**Addendum No. 001**

**Subject: 2020 Classroom Modernizations**  
**SDP Contract Numbers: B-022 C of 19/20 & B-024 C of 19/20**

**Location: Fox Chase School**  
**500 Rhawn St, Philadelphia PA 19111**

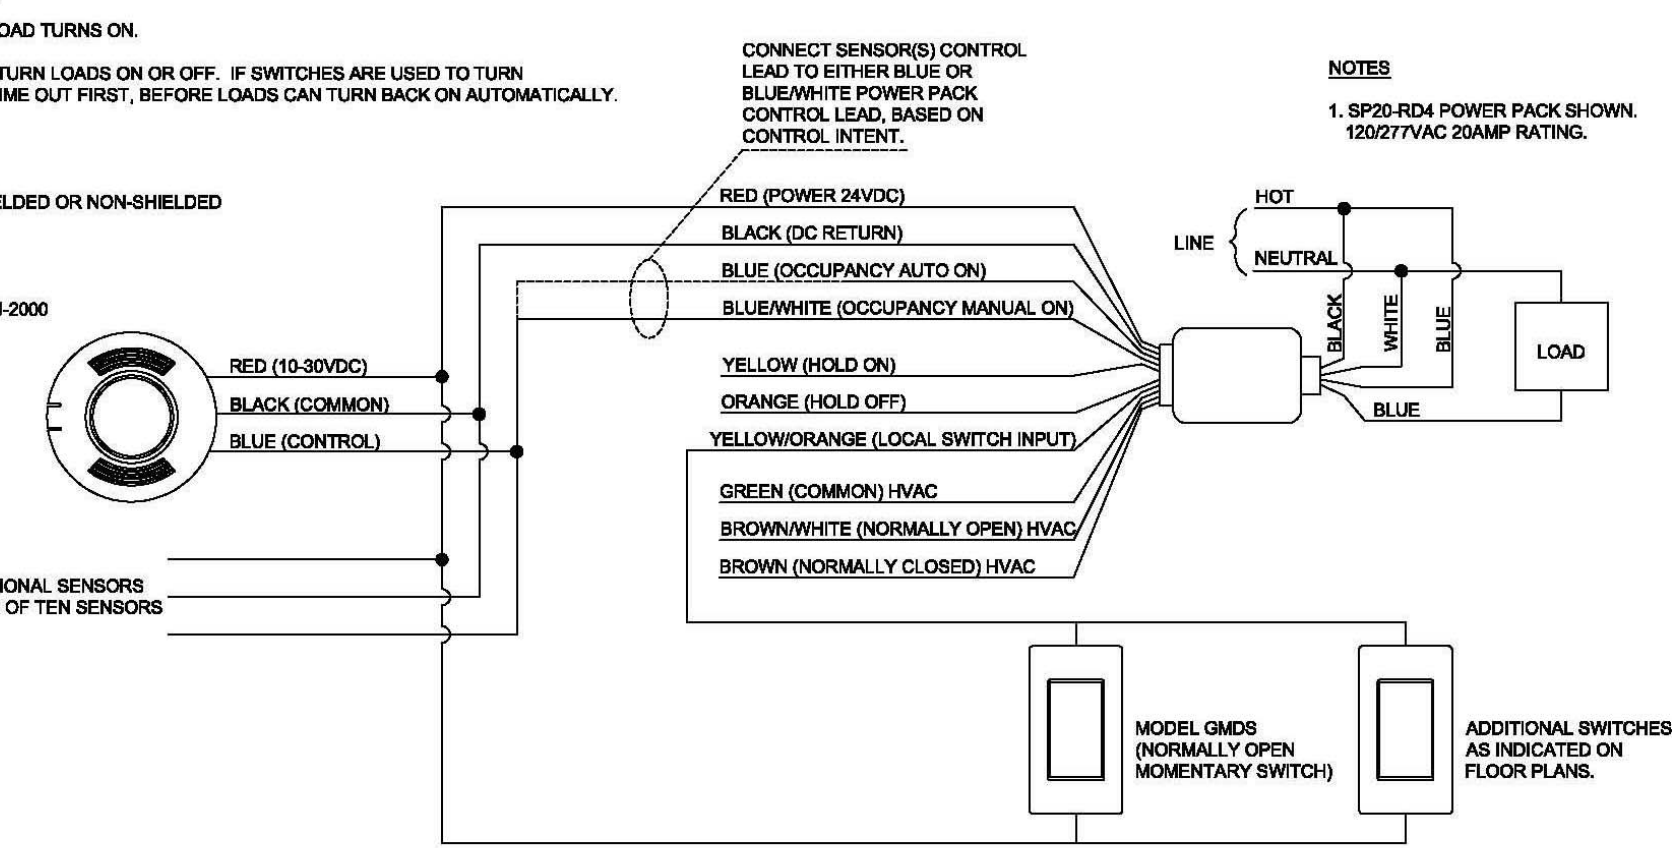
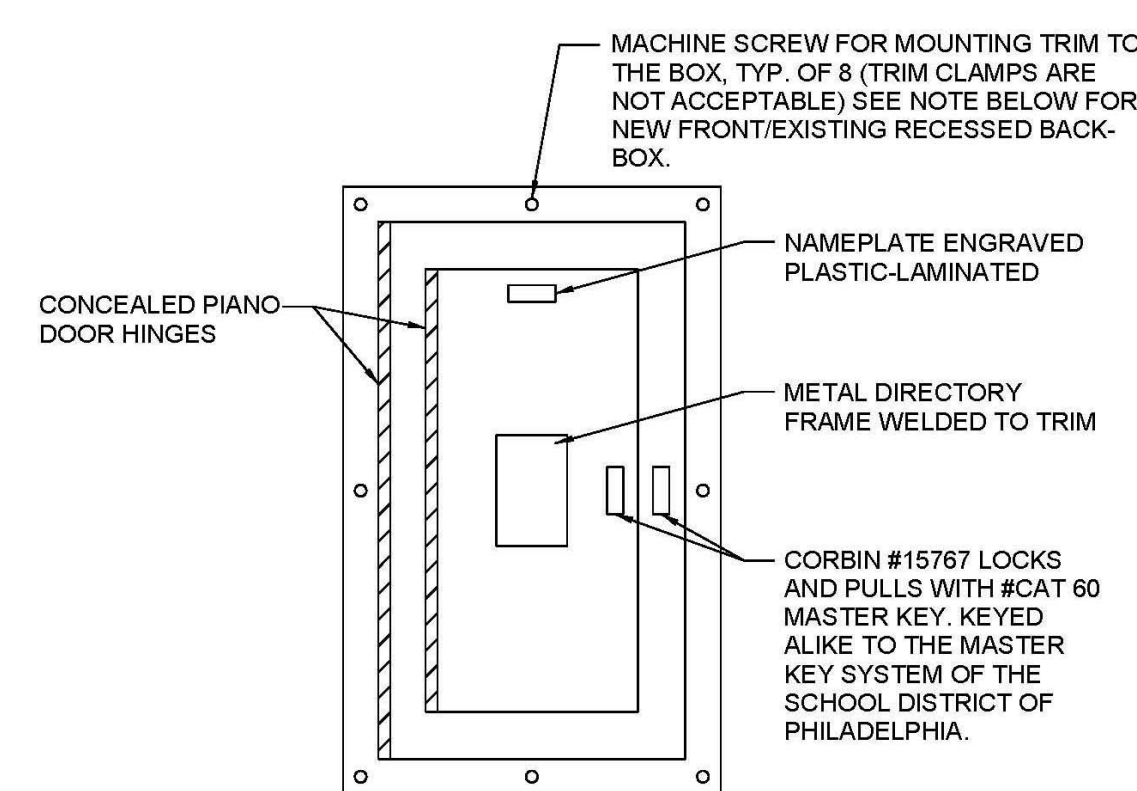
1. REVISE 3/E7.1 Typical Classroom Lighting Controller diagram as indicated on the drawings.
